OFFICIAL NOTICE OF DECISION

Project# 1010204

14DRB-70288 SITE DEVELOPMENT PLAN FOR BUILDING PERMIT
14DRB-70324 SIDEWALK VARIANCE

Project Name: ATRISCO BUSINESS PARK UNIT 4

ABQ ORTHODONTICS
SITE PLAN
ALBUQUERQUE, NM
PROJECT # 1332

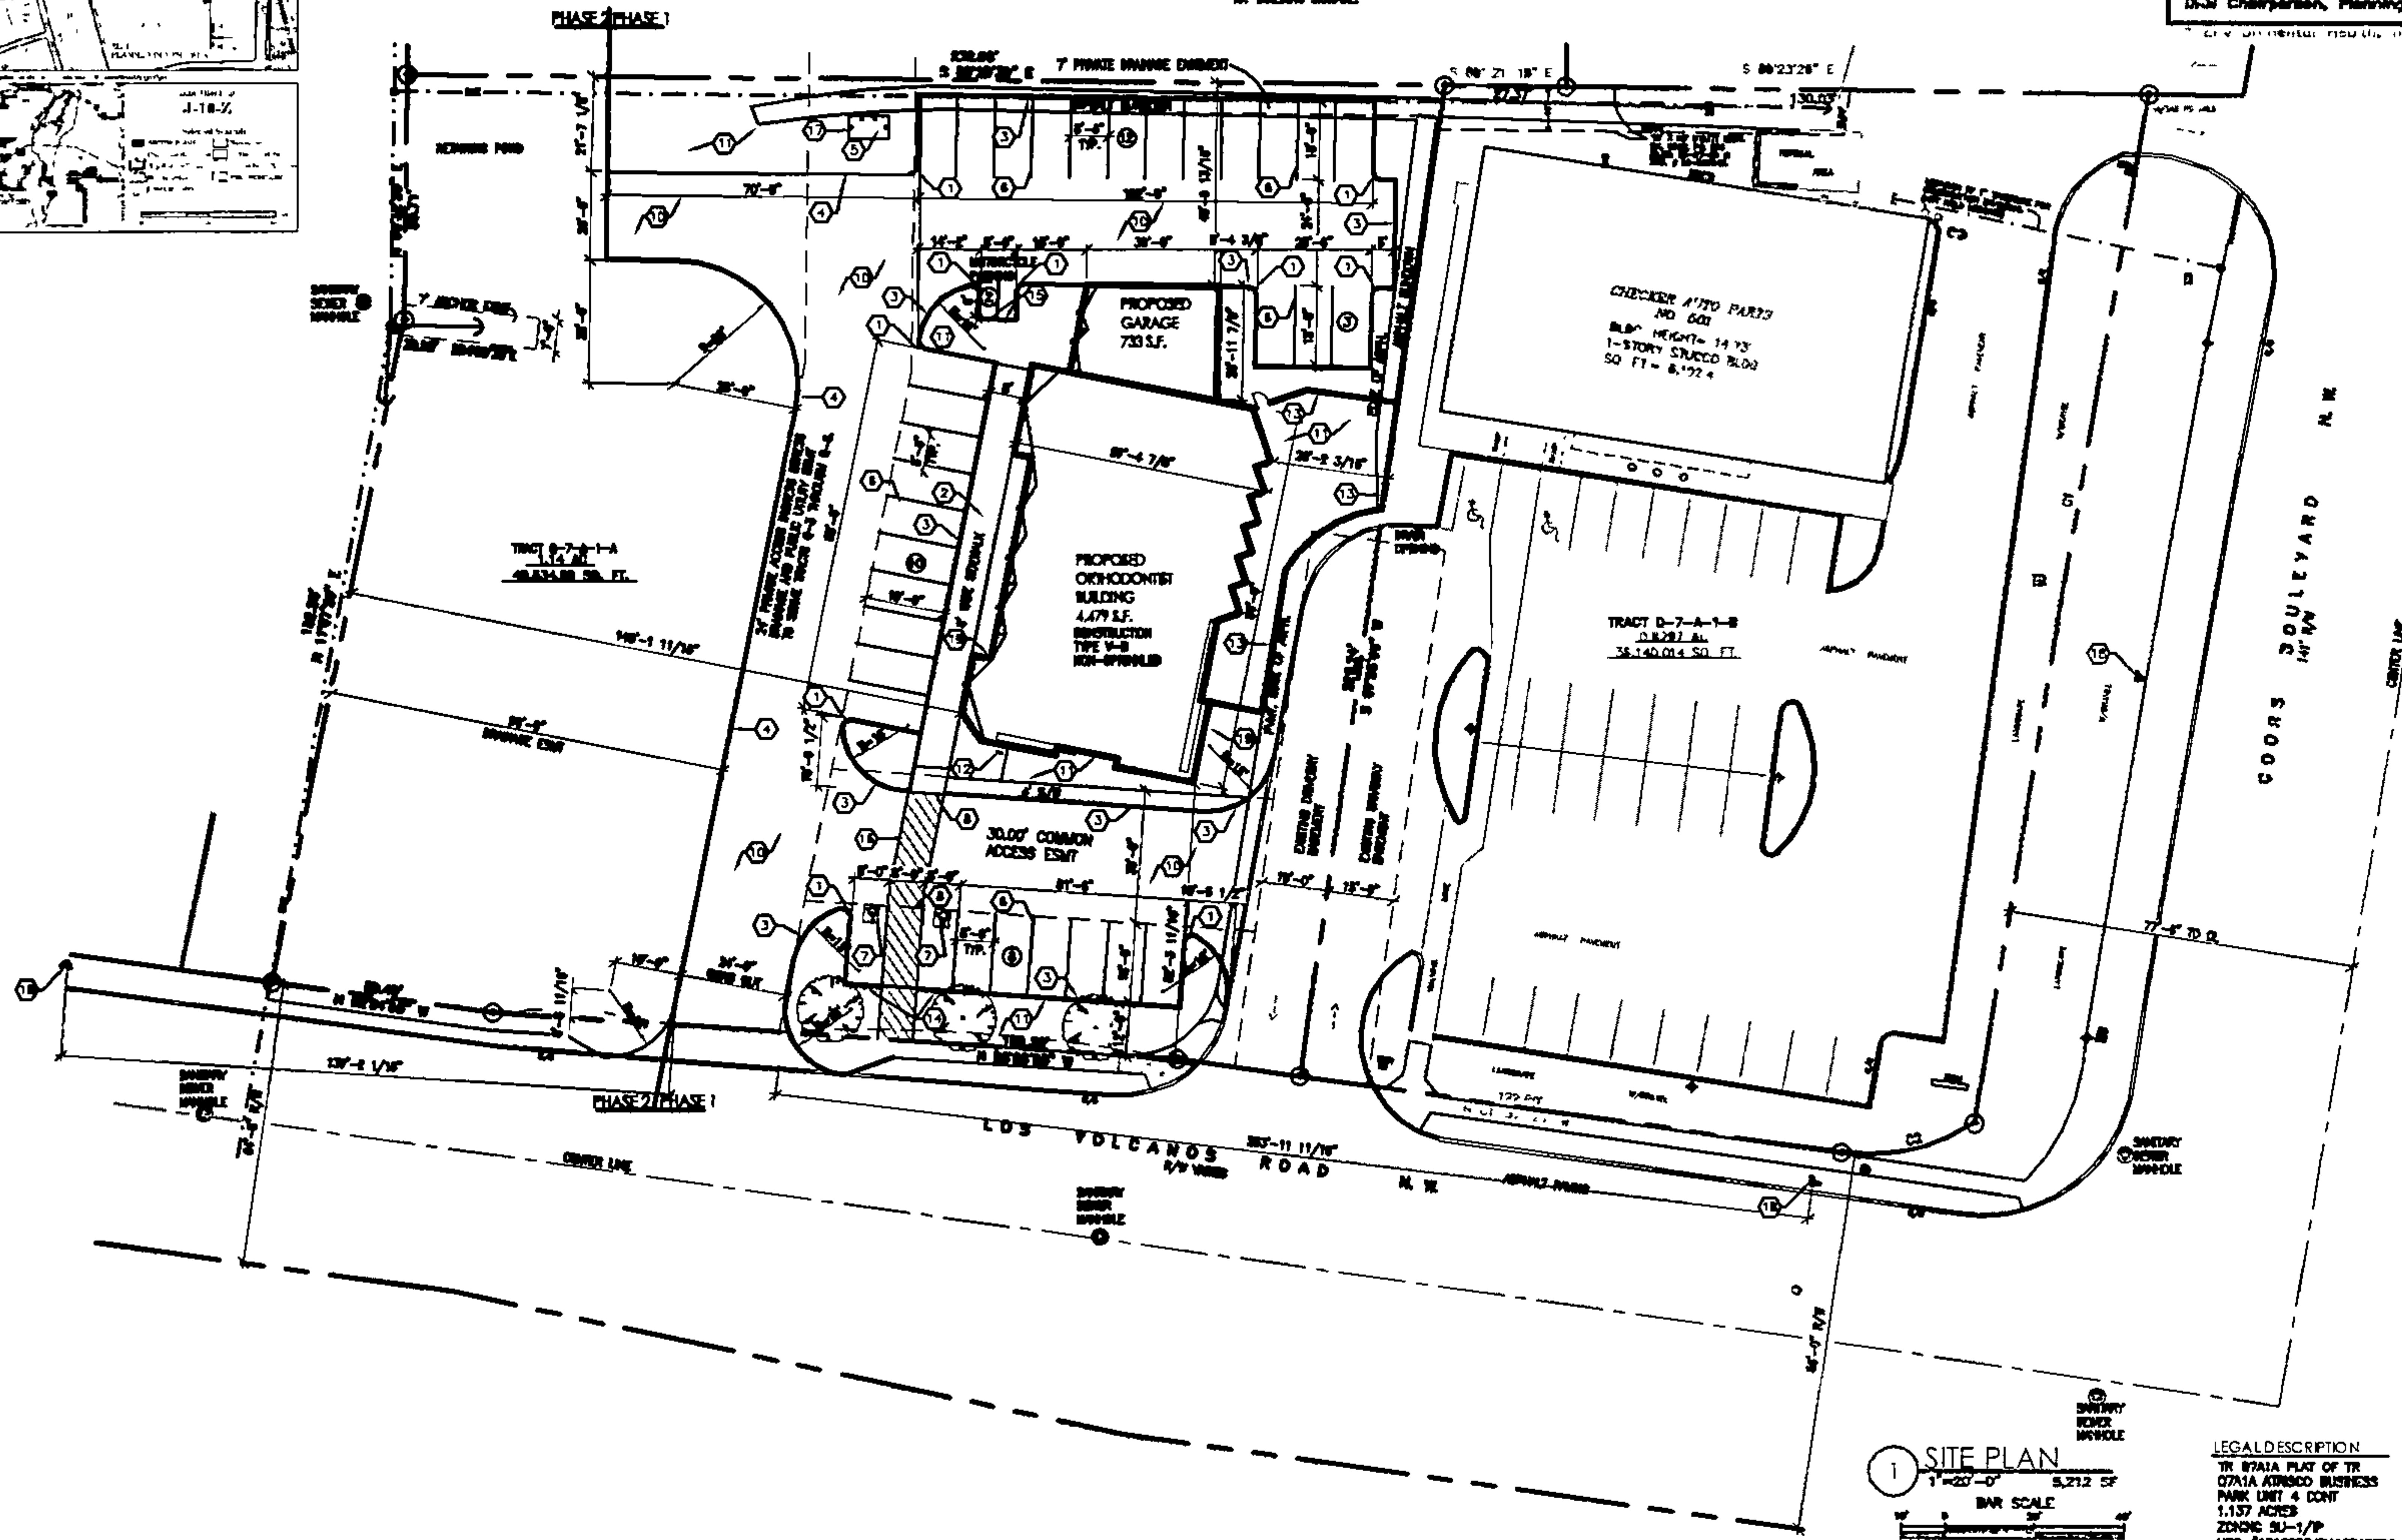
Zoning Enforcement needs to review and approve the site plan for conformance with the Zoning Code and Atrisco Master Plan.

Corrections needed include:

- 1) Recording information of existing easements needs to be noted on the site plan; also note if easements are 'Proposed.'
- 2) Patio wall color/ elevation needs to be noted in the site plan packet.
- 3) Landscape calculation table needs to be for 20% per Master Plan; landscaping is required along the south and east edge of the 90 foot Drainage Easement on the western portion of the site.

Provide an exhibit showing the location of sidewalk and defining the distance from back of curb to the property line. Right of way dedication may be required.

Los Volcanes Road is a collector in this area. As such, drives with full access require a 36-foot minimum width and a 20-foot minimum radius. In addition, collector roadways require a 6-foot wide sidewalk with a 6-foot setback from back of curb.

Provide recording information for the existing easements.

Show all ramps and provide details.

Provide a legend defining all hatching and linetypes.

DATE: 11-27-2013
SHEET NUMBER: CG-101

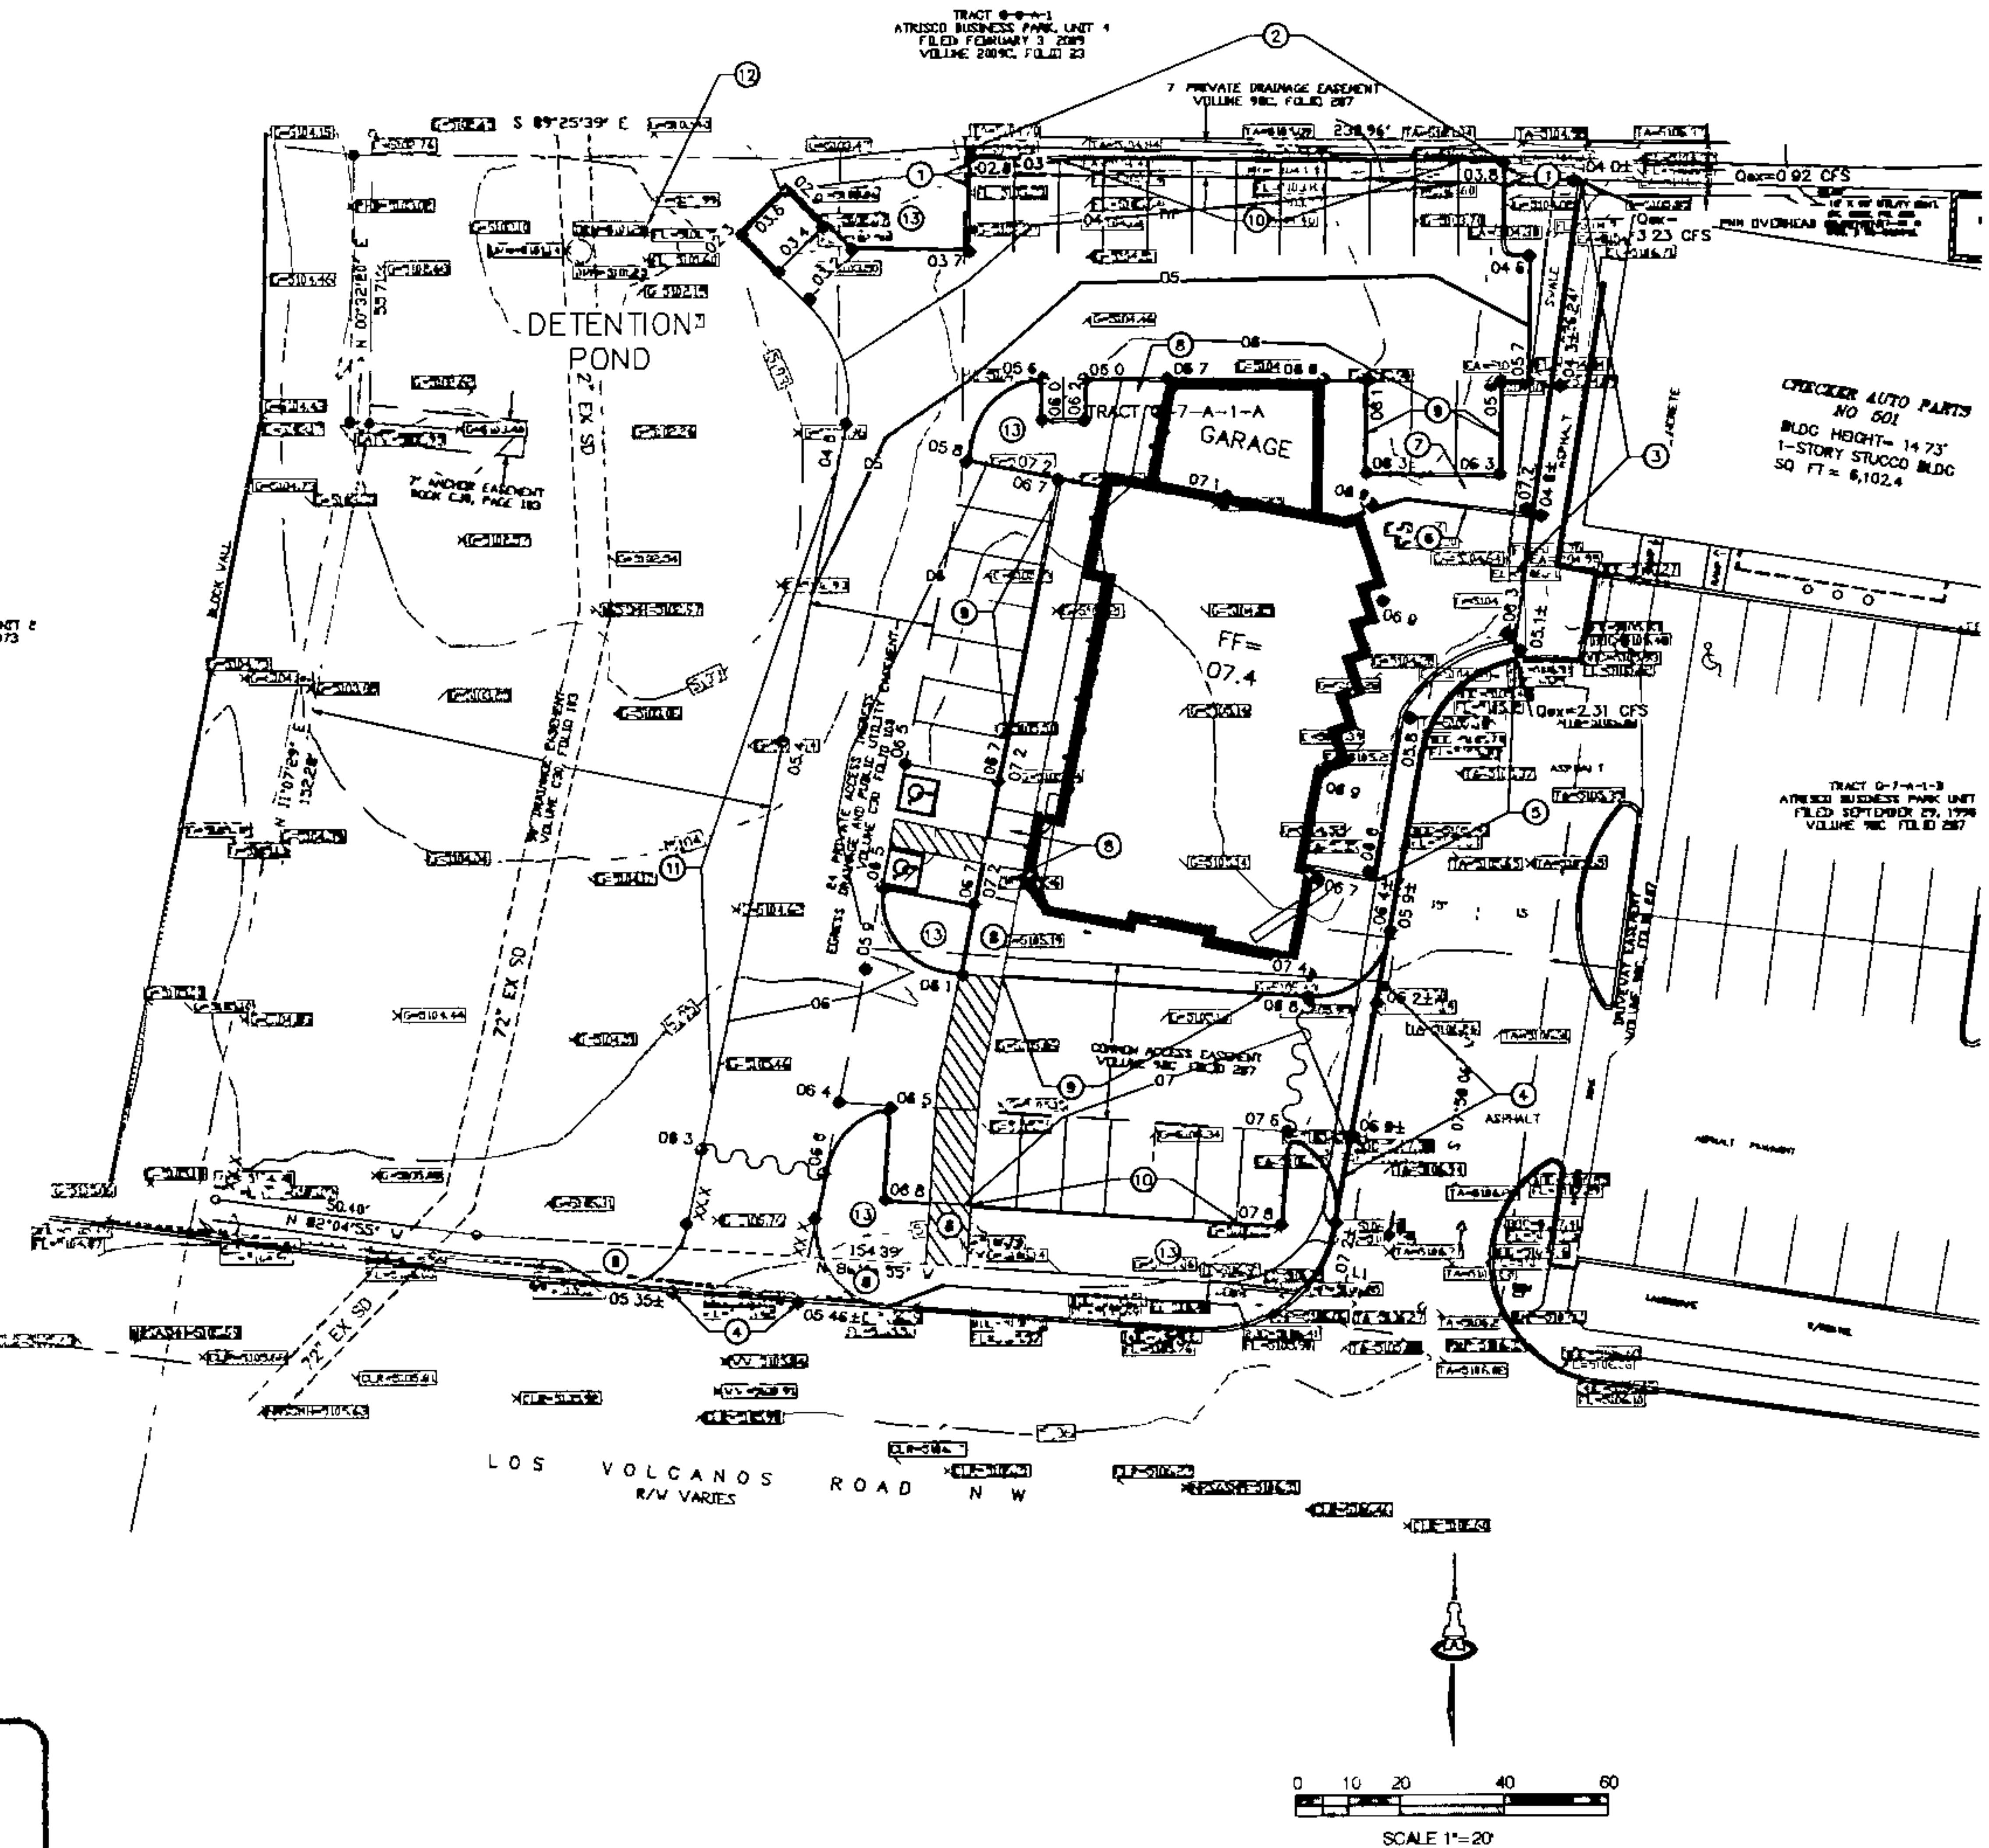
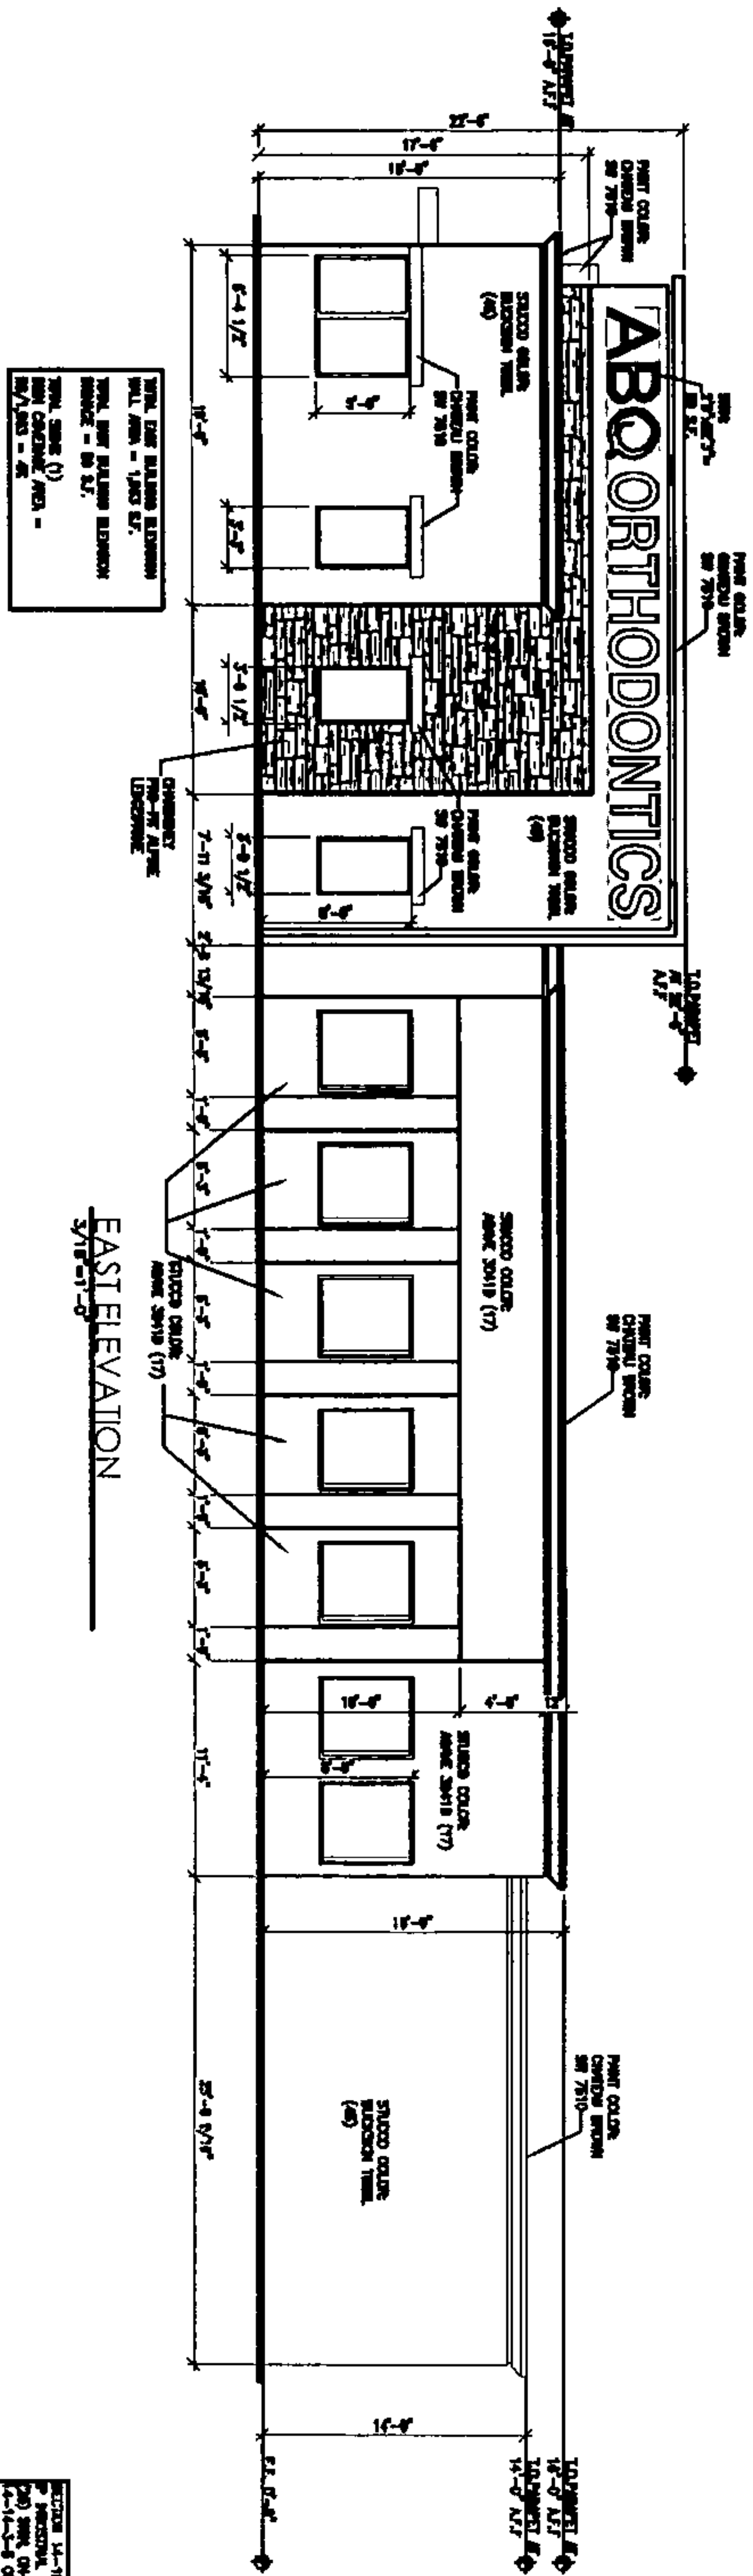
The grading and drainage plan does not match the site plan.

The proposed improvements in the 90 foot drainage easement may conflict with the existing inlet.

Improvements in this area were not shown on the grading and drainage plan.

Resubmit the grading and drainage plan.

This plan proposes work on an adjacent lot. Provide written approval from the property owner to the east.
